**441 Jane Street - Official Plan Zoning
By-law Amendment and Site Plan Control Applications -
Request for Direction Report**

Date:	March 24, 2014
To:	Etobicoke York Community Council
From:	Director, Community Planning, Etobicoke York District
Wards:	Ward 13 – Parkdale-High Park
Reference Number:	13 118452 WET 13 OZ and 13 118472 WET 13 SA

Attachment 1: Site Plan

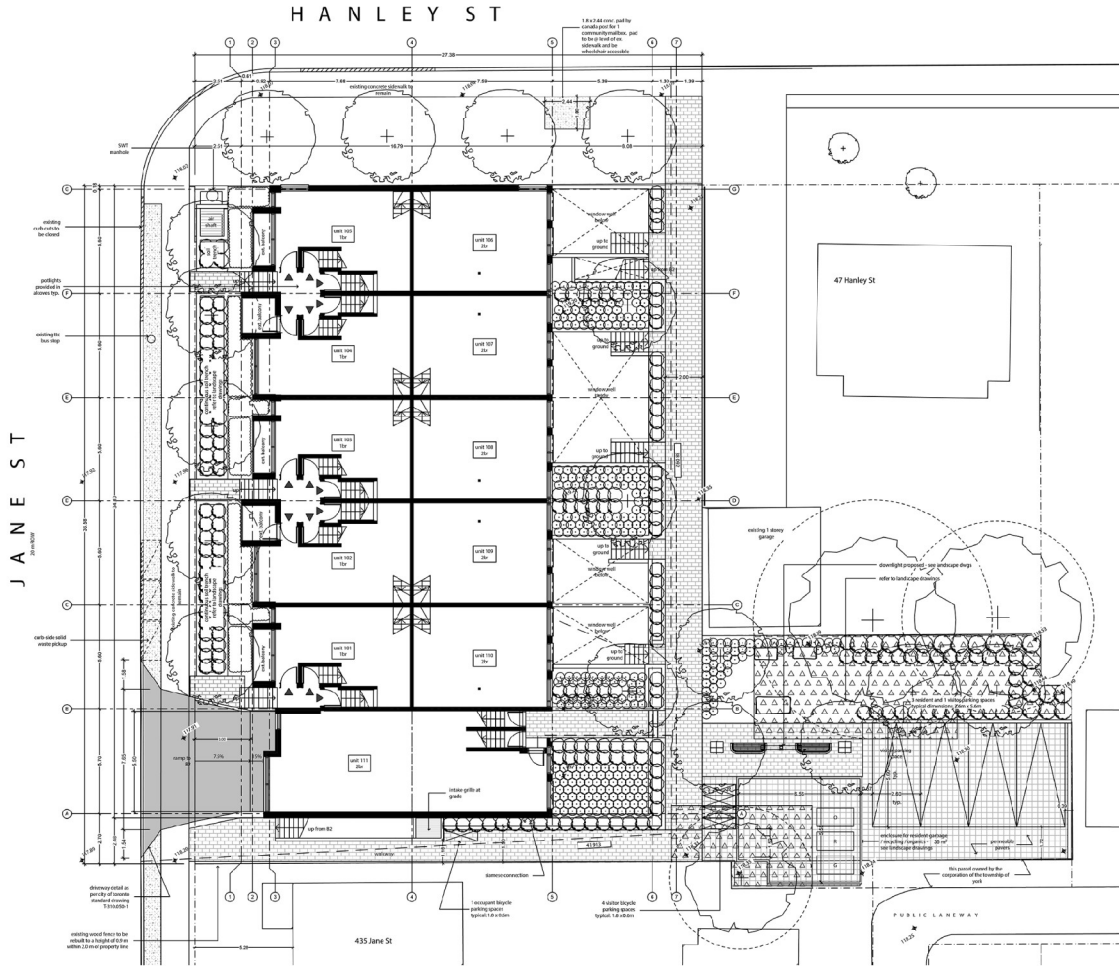
The current proposal provides amenity space at the rear of the building for six of the twenty-three units being proposed. The only access for these six units would be via a private walkway that is enclosed by fencing along the rear lot line adjacent to the neighbouring property. Five of these units would have sunken rear yard amenity space and one unit would have its amenity space at grade. This proposed condition does not provide for a safe or secure environment as none of these units front onto an existing public street with clearly visible and direct access from the public sidewalk. It is staff's opinion the proposal should be modified to provide for safe, visible access by eliminating

The proposed development would also provide no side yard setback from Hanley Street, which is not consistent with the setbacks of the adjacent properties. It is staffs opinion that a side yard setback should be provided to give greater exposure to natural sunlight on Hanley Street, to allow room for landscaping for better stormwater filtration, and to maintain the existing prevailing pattern of setbacks on the street, which would enhance the public realm. In addition, with a greater side yard setback and modified design treatments to the north and west facing building façades, the proposed development would have greater articulation from both Hanley Street and Jane Street and be more in keeping with the existing neighbourhood context.

Although the development would provide sufficient on-site resident parking, not enough visitor parking spaces are being provided. Further, a number of the proposed parking spaces in the underground garage are undersized based on current zoning standards. Additionally, an enclosed garbage storage area is proposed at grade in the southeast corner of the site that is in an inconvenient location for most of the units. It is staffs opinion that a more modest development with fewer units would allow for sufficient parking spaces to be provided underground. Further it would allow for the service area to be better incorporated into the design of the building.

Access to the proposed rear yard surface parking spaces remains an outstanding issue. The City-owned parcel that separates the site and the public lane has not been dedicated by the City as a public highway to provide direct access to the site. Therefore, the four parking spaces proposed at grade (3 resident and 1 visitor) cannot be accessed without this parcel of land being dedicated. Should the development be approved, staff are recommending the Ontario Municipal Board be requested to withhold its Order until the City-owned parcel is dedicated as public lane.

the sunken amenity space and providing main building entrances fronting onto Jane Street.

Attachment 2a: Elevations

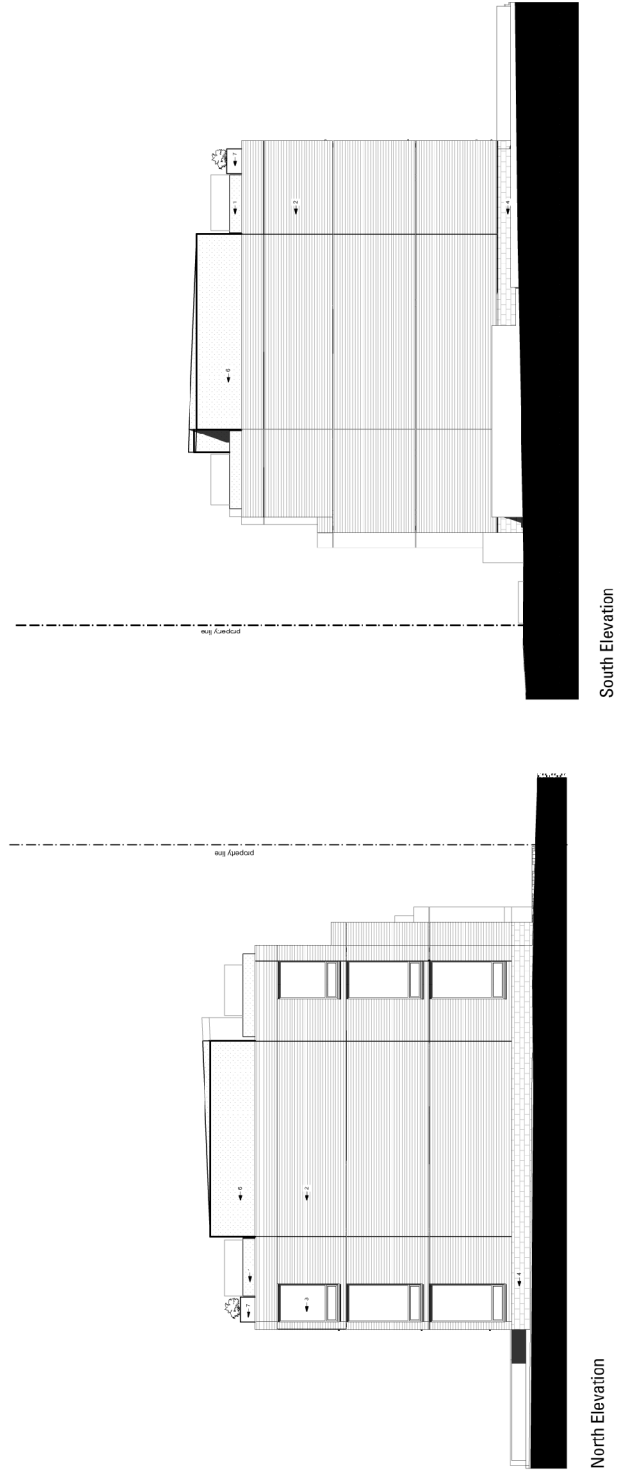
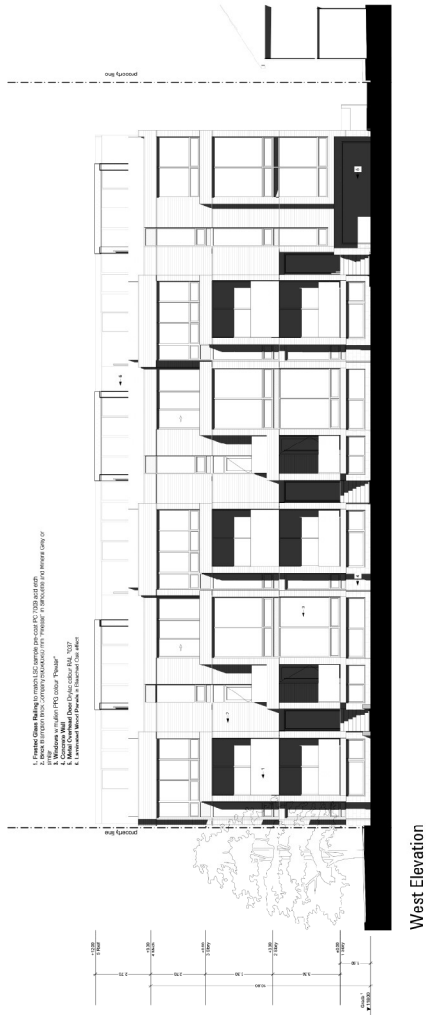
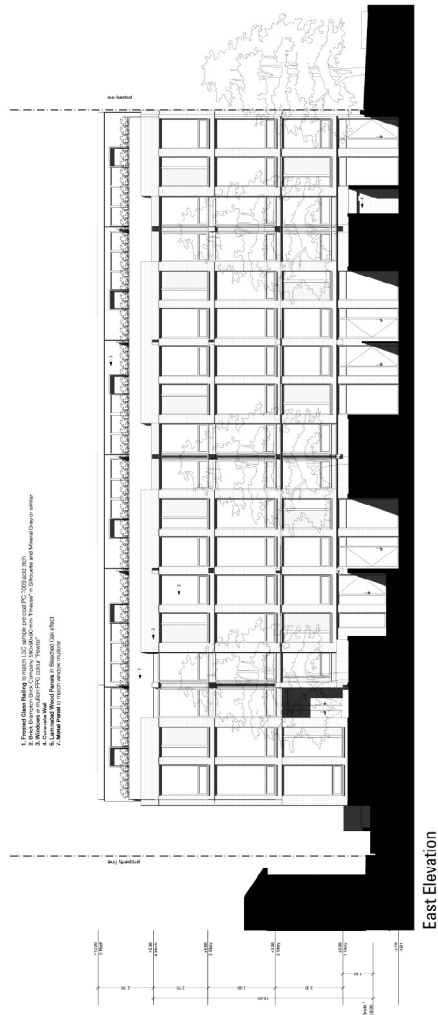
The application also proposes a building height of 13.5m with four and a half storeys above grade. The R2 Residential zoning of the surrounding established neighbourhood permits buildings with a maximum height of 11m with not more than three-storeys. This is consistent with the new City wide Zoning By-law 569-2013, which is applicable to the surrounding neighbourhood.

Therefore, the proposed height and storeys are not consistent with the applicable Zoning By-law. Further, the built form and massing does not provide for a development that meets the objectives of Section 4.1 of the Official Plan. As proposed, the development would result in a scale and massing that is inconsistent and not compatible with the existing surrounding physical neighbourhood.

A more modest scale of development that provides for a reduced building height, compliance with Zoning By-law parking standards, grade related directly accessible rear yard amenity space, main unit entrances accessed from a public street (Jane Street) with appropriate development setbacks and a built form that is more in keeping with current Zoning By-law requirements and more sensitive to the predominant existing built context of the neighbourhood, would be more appropriate for this site.
